Accessibility Survey

City of Downey Century Boulevard - End To Downey Avenue

Date of Inspection
11/29/2016

Prepared By
Disability Access Consultants
(800) 743-7067

Tree East Of Earnshaw Avenue @ 33.905656725219, -118.149740695953

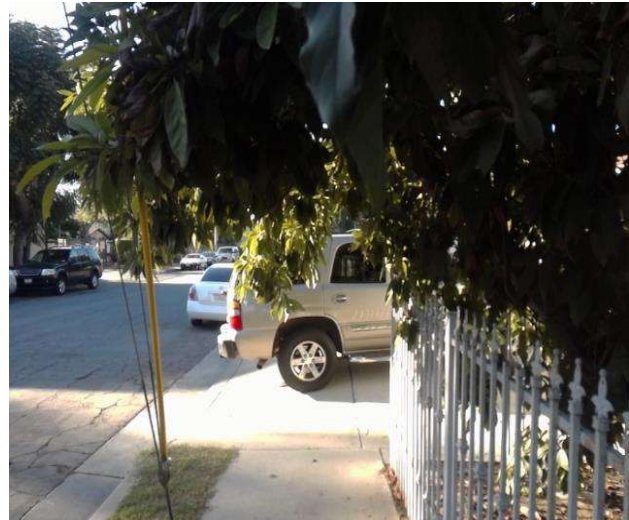
Sidewalks , Hazards & Gratings : Overhead Obstruction Height

Overhead obstruction height is not compliant.

On-Site Finding 48.00 inches

Provide a compliant vertical clearance height.

Recommendation At least 80.00 inches
